HANNAH HOUSE SUBDIVISION

APPLICATION NUMBER 8 DATE May 5, 2016

APPLICANT Hannah House Subdivision

DETAIL SITE PLAN

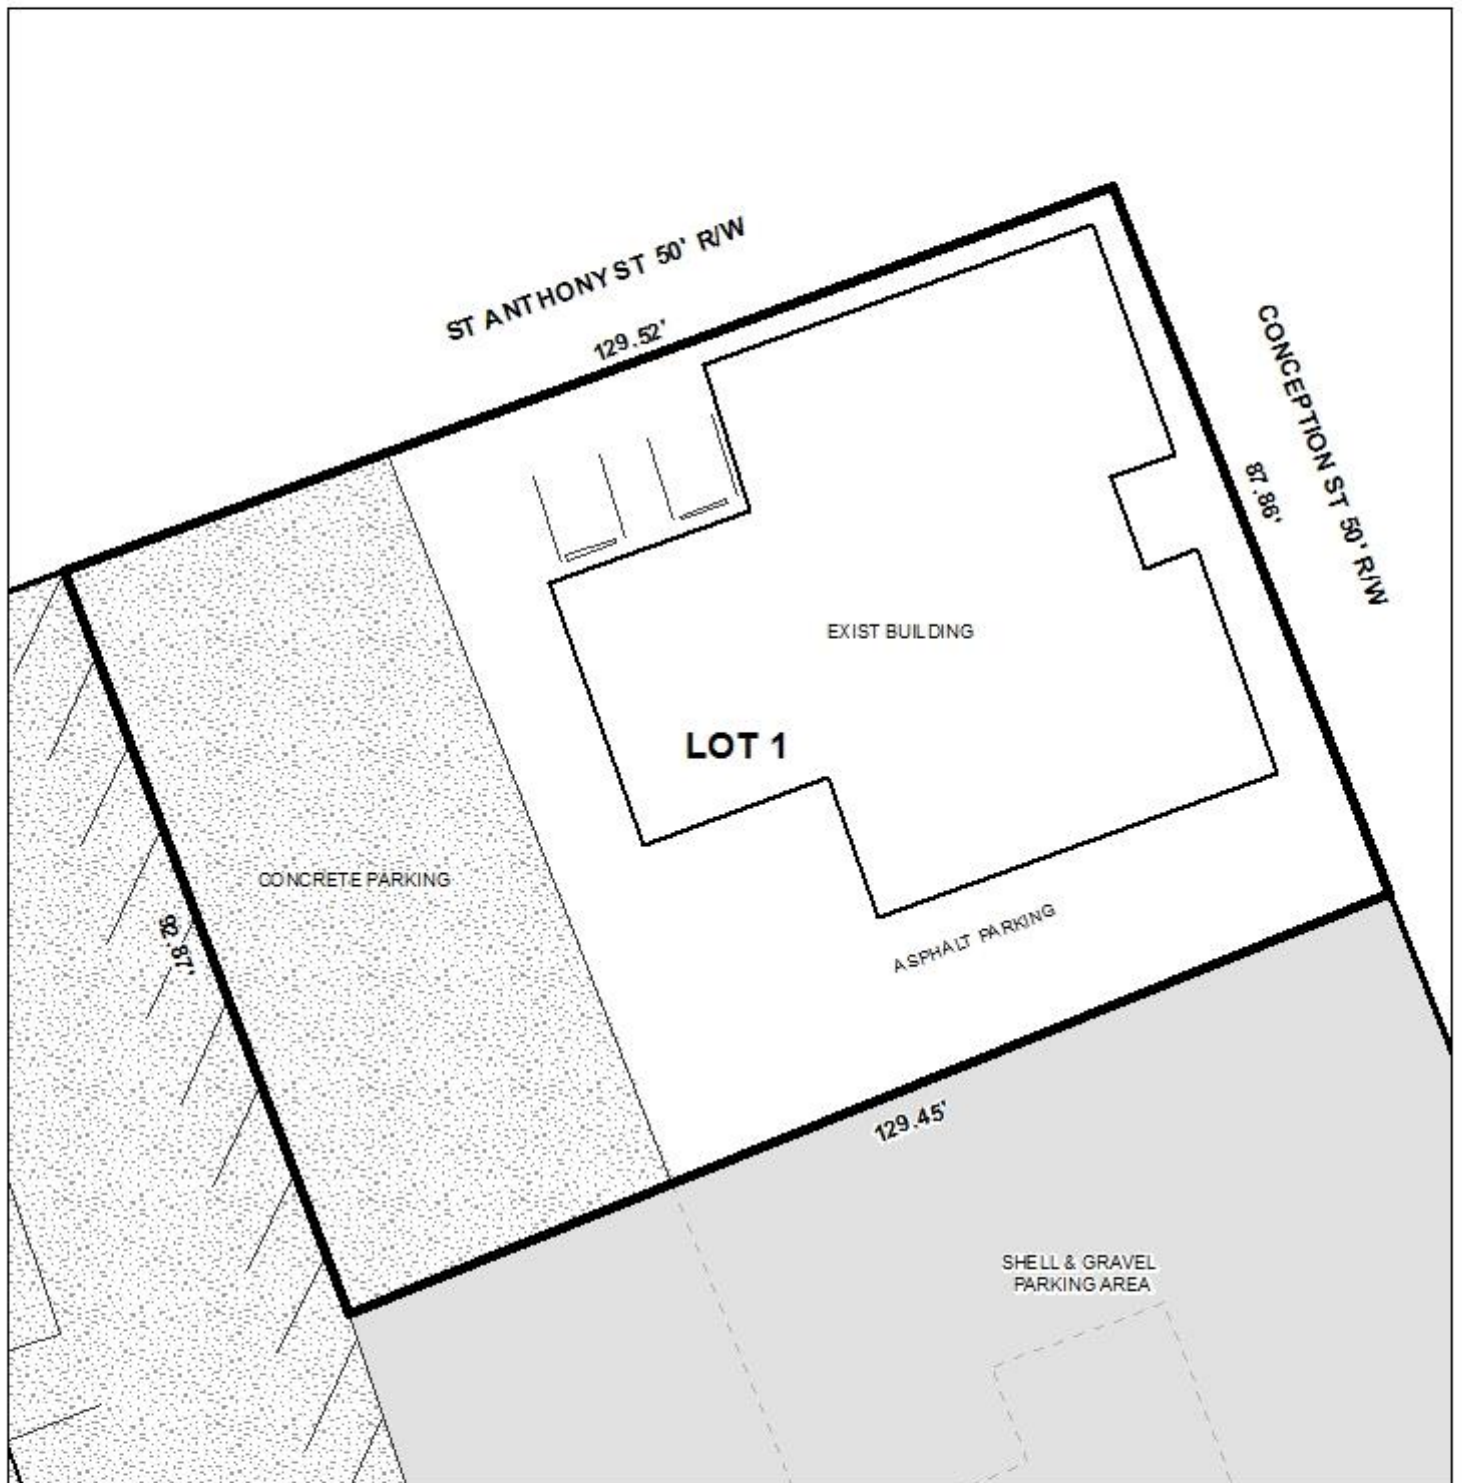
The 25-foot minimum building setback line, required in Section V.D.9., is not shown for the subdivision. As the site is located within a T-4 sub-district of the Downtown Development District, and as setbacks are not required in this sub-district by the Zoning Ordinance, a waiver of Section V.D.9. would be appropriate.

Finally, the size of the lot is not labeled on the preliminary plat. The final plat should include the lot size in square feet.

- 1) placement of a note on the final plat stating that any modification to the number, size, design or location of any existing or proposed curb-cuts should be coordinated with the City of Mobile Traffic Engineering Department and conform with AASHTO standards;
- 2) the labeling of the lot size in square feet;
